ADDENDUM TO RFP DOCUMENTS

SOLANO COMMUNITY COLLEGE	ADDENDUM #02
	Project: Solano Community College District Vacaville Center HVAC Upgrade Project Project #18-010
	Date: February 28, 2018

Addendum # 02 – The following clarifications are provided based on questions received and must be added/considered when completing your submittal: Acknowledgement of receipt of this **ADDENDUM** is required in the proposal’s cover letter of introduction. Please clearly note the addendum date and number.

3 COPING CONTROL JOINT
3" = 1'-0"

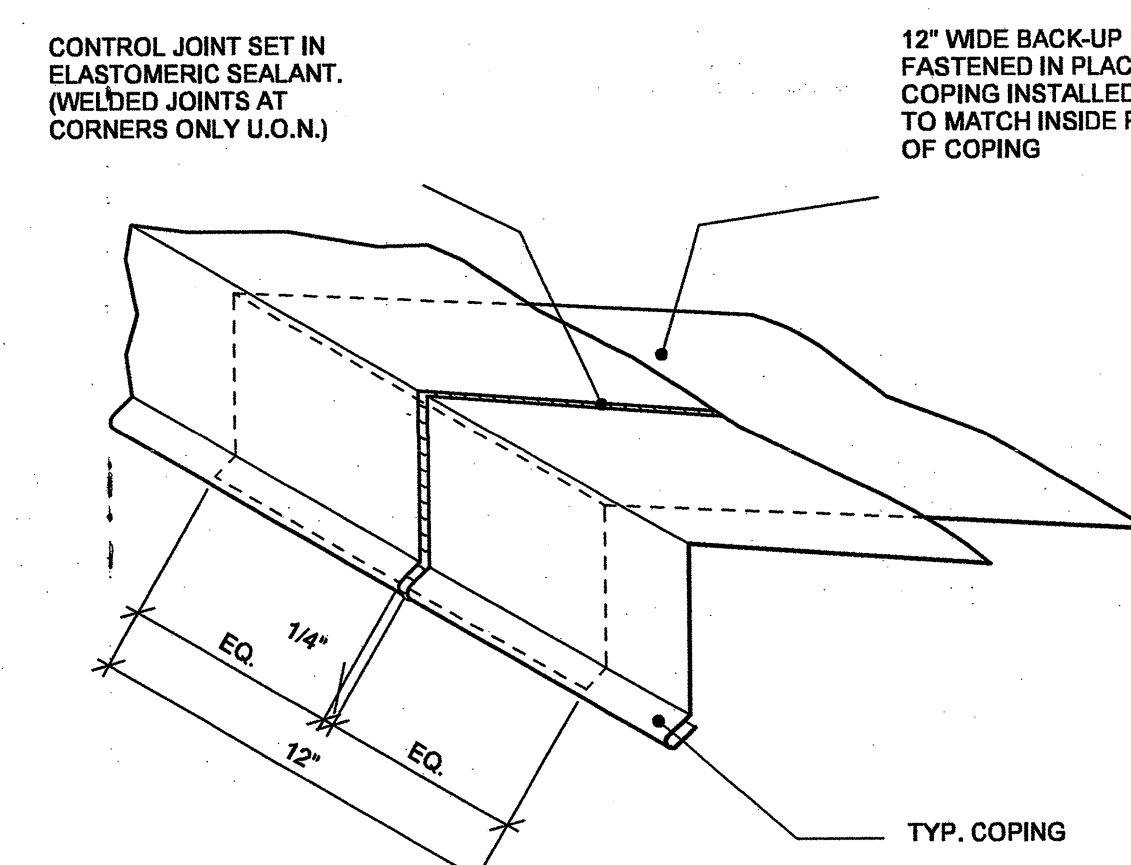
QUESTION –During the job walk it was determined that the existing roof system is fully tapered by rigid insulation ½” in 12” slope with a minimum of 6” at drains but not shown on the drawings. Please confirm and provide new details identifying existing insulation.

ANSWER – Please see the attached As-built drawings: A8.51, A8.52 & A8.53 for all the info of the existing roof condition (see attached).

CONDENSATE CONNECTION DETAIL

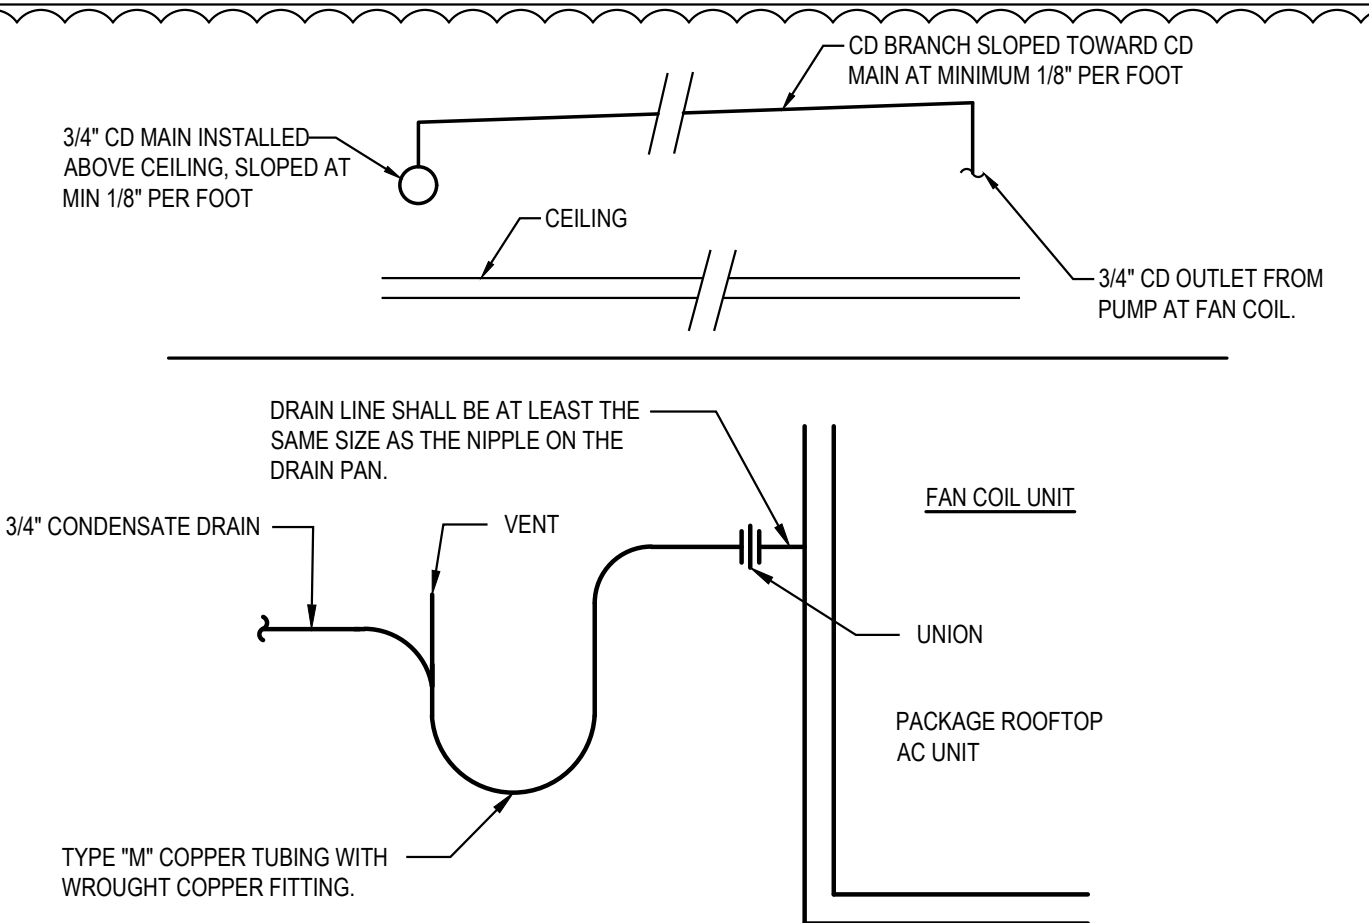
QUESTION –The new Fan Coil Units require a condensate pump. Please provide a connection detail and circuits to be used.

ANSWER – Refer to attached sheet M0.02 (see attached).
